Re: NOI, Baxter Road and Sconset Bluff Storm Damage Prevention Project

MEMORANDUM

Date: July 29, 2013
To: Emily MacKinnon and Cormac Collier, Nantucket Land Council
From: John Ramsey, P.E. and Trey Ruthven
Subject: Baxter Road and Sconset Bluff Storm Damage Prevention Project

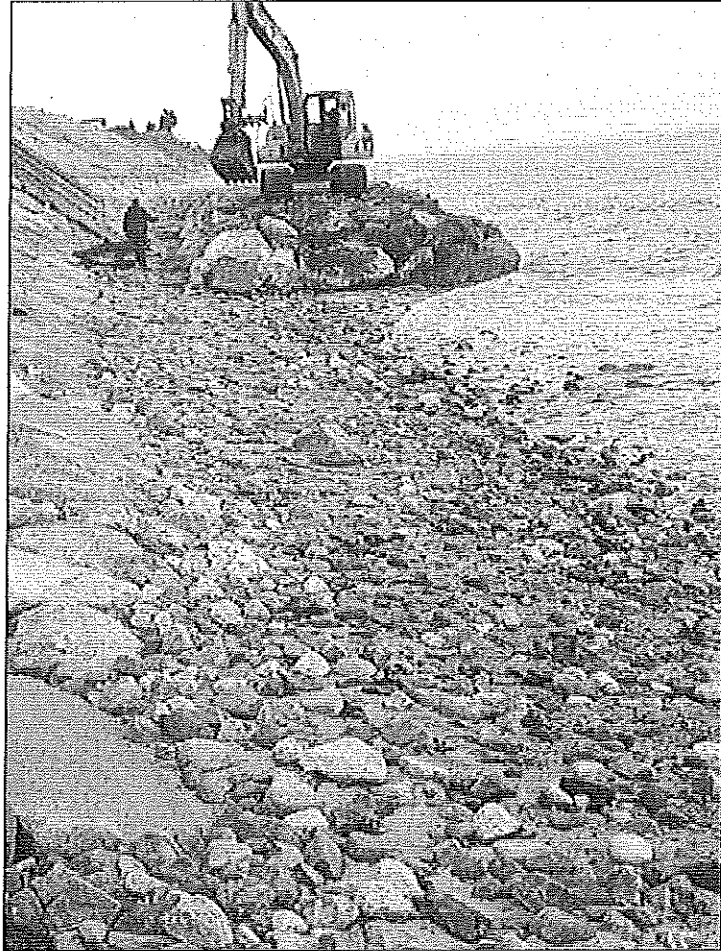
1. The Applicant provided numerous examples of armor stone revetments along the coast of Massachusetts; however it is unclear (a) whether any of these (or other) revetments are in an area with bluff erosion rates in excess of 5 feet per year and (b) what the long-term impact on downdrift beaches has been as a result of revetment construction. We did not indicate that revetments could not be constructed in this level of wave energy, but rather that we are unaware of successful revetments that have been constructed in areas with excessively high natural erosion rates (in excess of 5 feet per year, as demonstrated below). Again, the applicant should provide examples of where revetments have been successful on coastal banks/bluffs with erosion rates similar to the Sconset Bluff, where the structure has provided long-term bank stability and downdrift impacts have been negligible and/or mitigated with nourishment. Information provided to date merely indicates that other

revetments have been constructed in Massachusetts, but does not provide any documented evidence of revetments in similar erosional environments. For example, the Triton Way revetments are in an area with long-term erosion rates of less than 1 ft/yr and as demonstrated, the areas fronted by revetments no longer have a high tide beach.
